EFFECTIVE DATE:	This SAFETY ALERT is effective May 05, 2009		
SUBJECT:	Corrosion Potential		
MODELS AFFECTED:	CC11 S/N 00001 thru S/N 00099, excluding S/N 00095		
COMPLIANCE TIME:	Replace at Next Maintenance Action		
PURPOSE:	Replacement of the three (3) empennage wire brace attachment brackets.		
PARTS LIST:	PART NUMBER	DESCRIPTION	REVISION
	SC81206-001	Vertical Stabilizer Wire Attach	D or Higher
	SC81007-001	Horizontal Stabilizer Wire Attach, Left	G or Higher
	SC81007-002	Horizontal Stabilizer Wire Attach, Right	G or Higher

FIGURE 2 - Upper Wire Attach

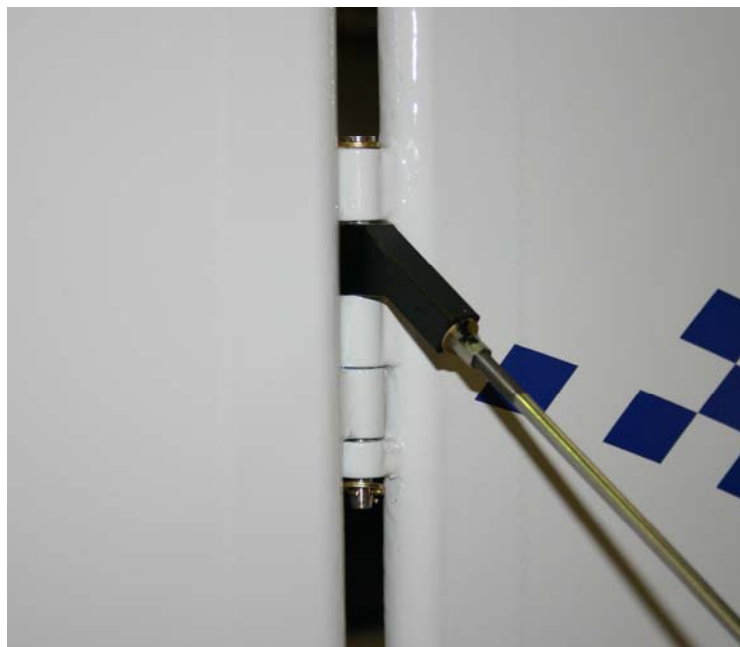
1. Contact Cub Crafters Customer Support for replacement parts SC81206-001 (Revision D or higher), and SC81007-001 and SC81007-002 (Revision G or higher). When replacement is performed, follow the Maintenance Manual Section 6.3.5 "Empennage" for proper rigging and tensioning of wires.
2. Make log book entries identifying replacement parts and their revision levels (Part Number and Revision level are noted on part sticker).
Example: "Original SC81206-001, SC81007-001 and SC81007-002 have been replaced with SC81206-001 Rev. E, SC81007-001 Rev. H, and SC81007-002 Rev H per Safety Alert SA0006."
